Consolidated Edison Company of New York, Inc.
Indian Point Station
Broadway & Bleakley Avenue
Buchanan, NY 10511
Telephone (914) 734-5340
Fax: (914) 734-5718
blinda@coned.com

Re: Indian Point Unit No. 2
Docket No. 50-247
NL 01-092

SUBJECT: Indian Point 2 License Amendment Request for Reactor Coolant System Heatup and Cooldown Limitation Curves and Request for Exemption from the Requirements of 10CFR50.60(a) and Appendix G

Figure 3.1.A-3 Maximum RCS Pressure: OPS Inoperable and 2 Charging Pumps Capable of Injecting into the RCS

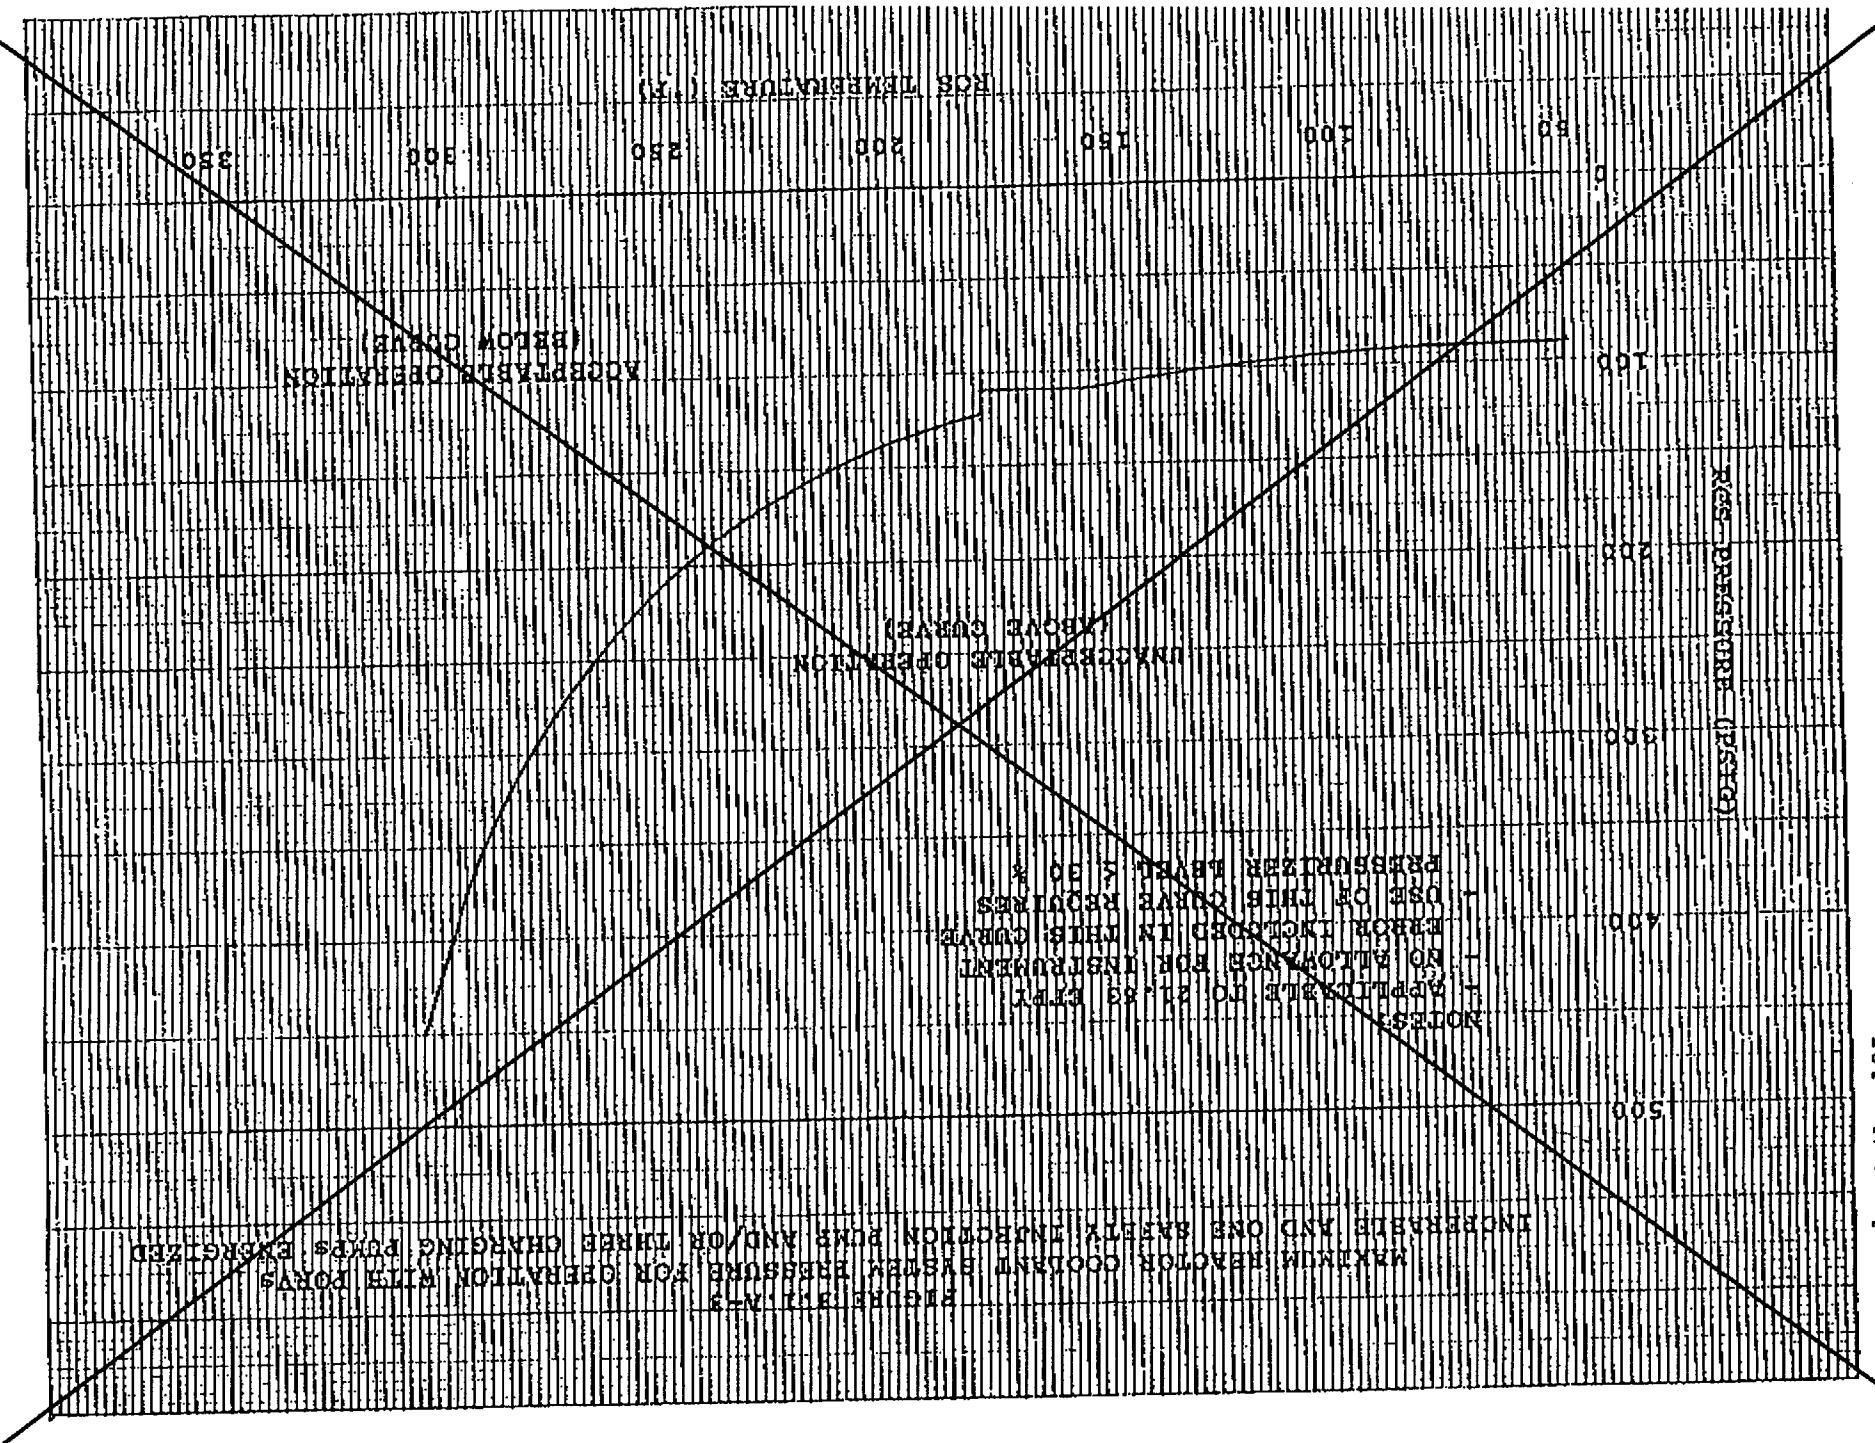
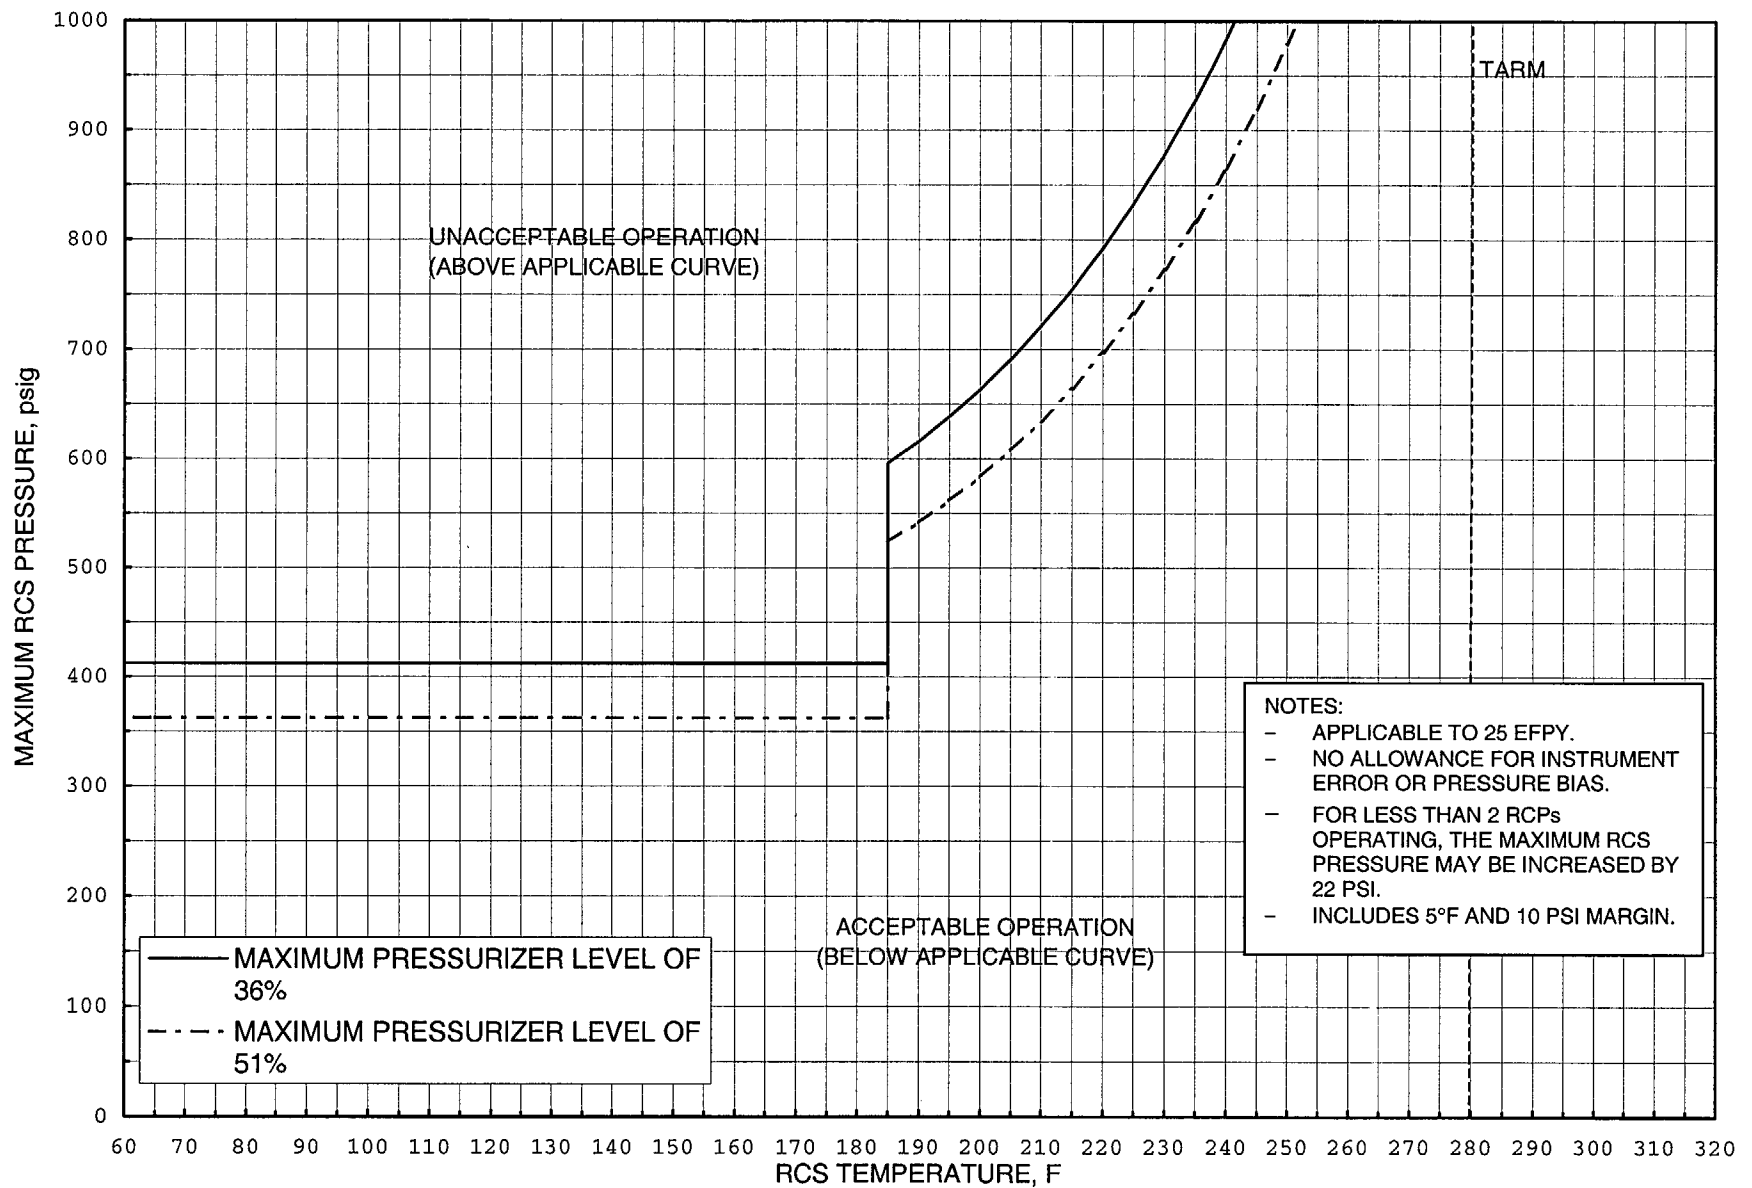
7. Figure 3.1.A-3 Maximum Reactor Coolant Pressure for Operation with PORVs Inoperable and One Safety Injection Pump And/Or Three Charging Pumps Energized

Figure 3.1.A-5 Maximum RCS Pressure: OPS Inoperable and Start of 1 RCP with SGs 40°F Hotter than RCS

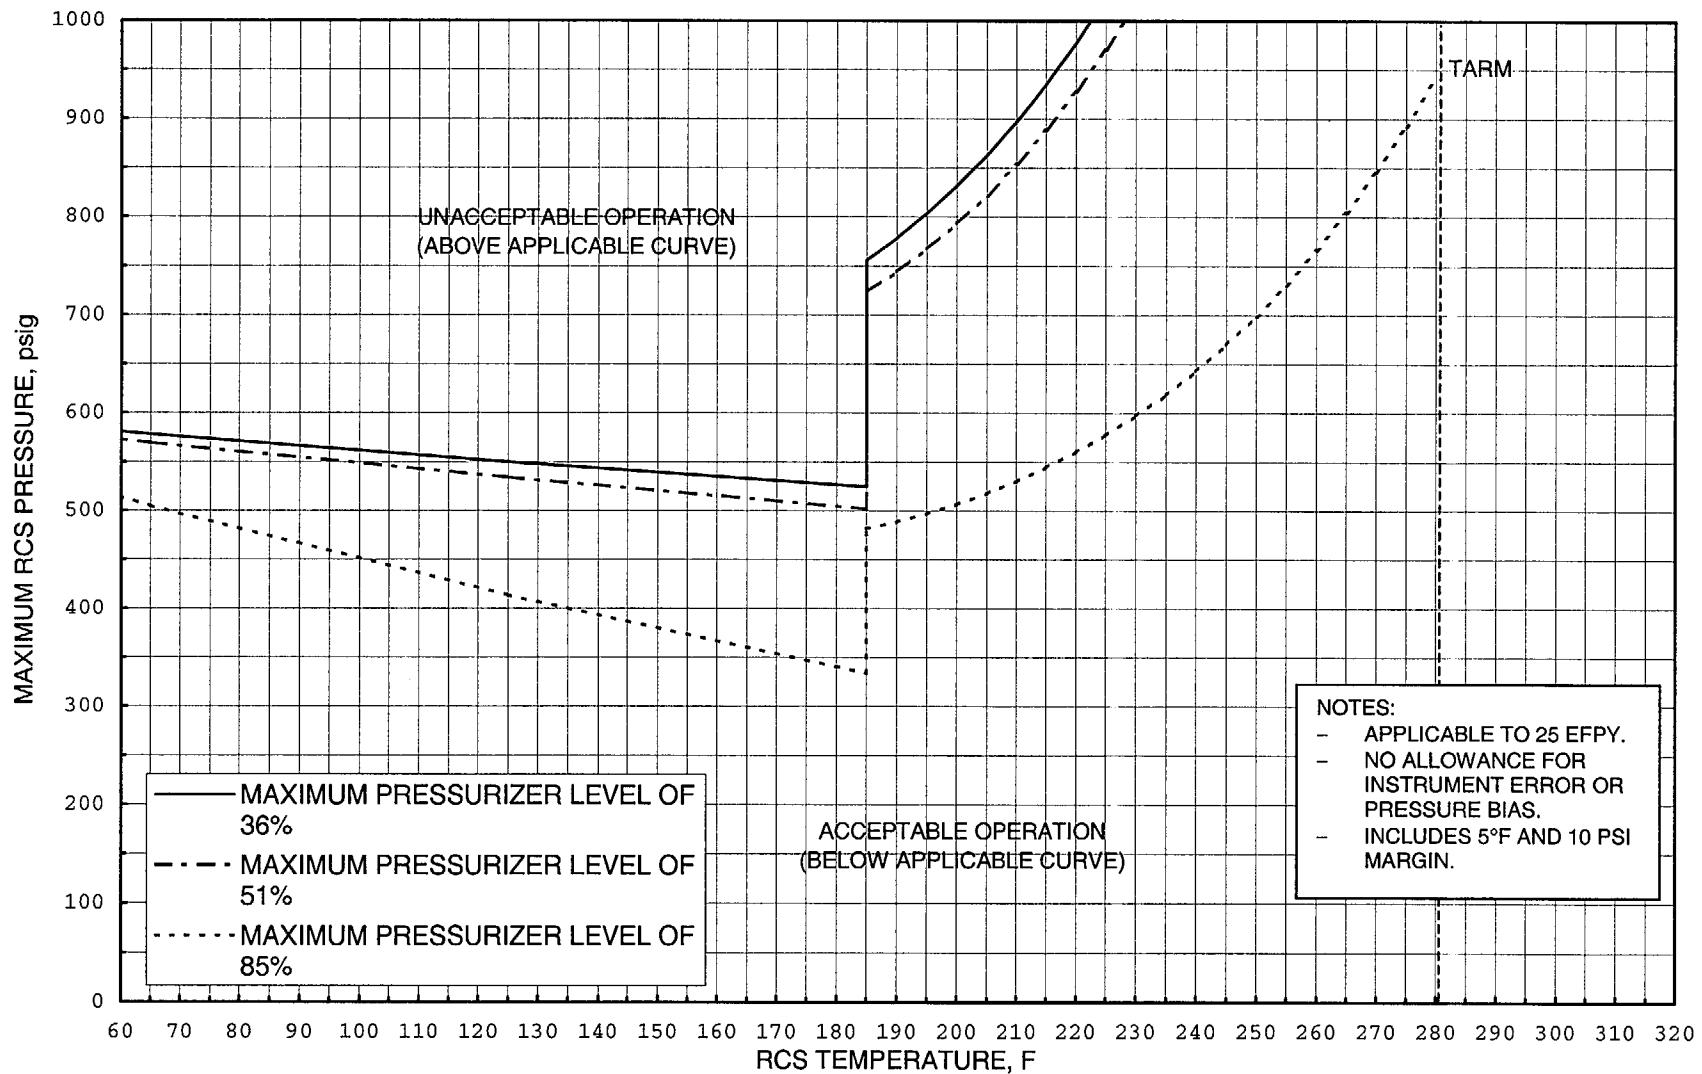
1. Figure 3.1.A-4 Maximum RCS Pressure: OPS Inoperable and 3 Charging Pumps Capable of Injecting into the RCS
2. Figure 3.1.A-5 Maximum RCS Pressure: OPS Inoperable and Start of 1 RCP with SGs 40°F Hotter than RCS
3. Figure 3.1.A-6 Maximum RCS Pressure: OPS Inoperable and Start of 1 RCP with SGs 100°F Hotter than RCS

- (1) The temperature of all steam generators is less than or equal to the RCS temperature, or
- (2) ~~The temperature of all steam generators is less than or equal to 40°F higher than the RCS temperature and:~~
 - ~~o RCS pressure operating restrictions are as specified in figure 3.1.A-5~~
- (3) The temperature of all steam generators is less than or equal to 100°F higher than RCS temperature and:

Figure 3.1.A-6 Maximum RCS Pressure: OPS Inoperable and Start of 1 RCP with SGs 100°F Hotter than RCS

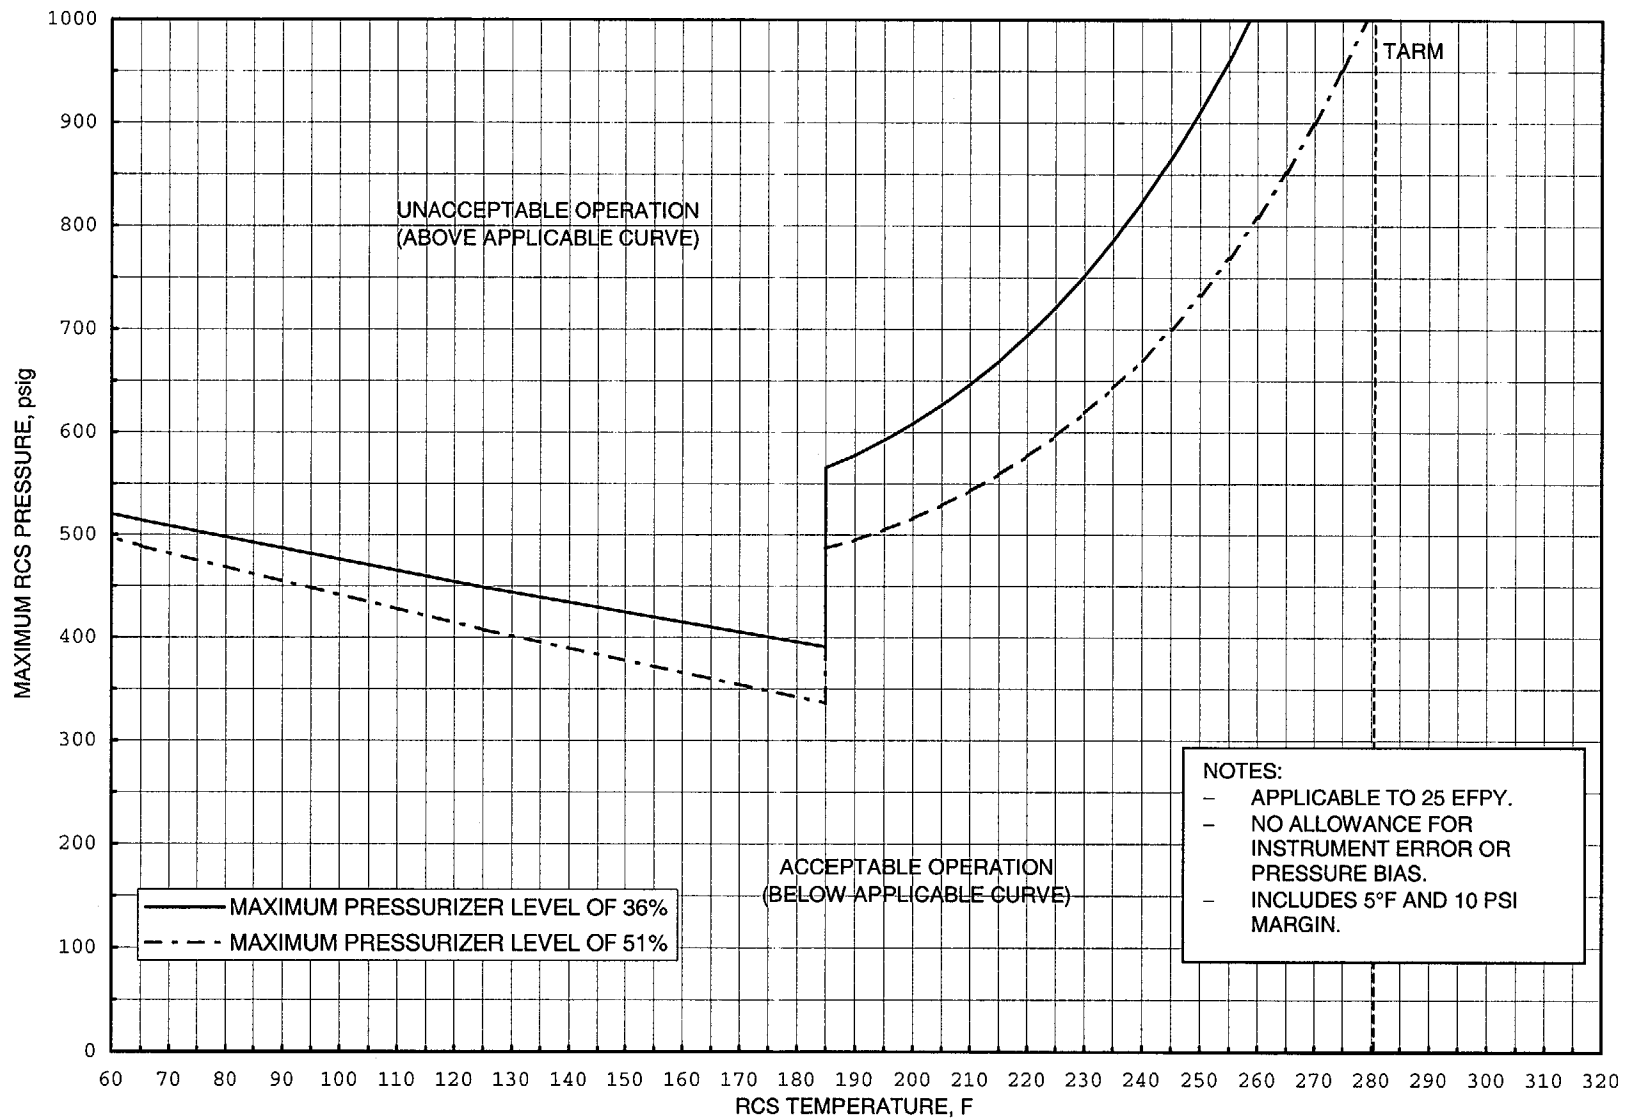
- ~~o RCS pressure is less than or equal to 450 psig,~~
- ~~o RCS temperature is greater than or equal to 145°F,~~
- ~~o Pressurizer level is less than or equal to 30% of span.~~
- o RCS pressure operating restrictions are as specified in Figure 3.1.A-6
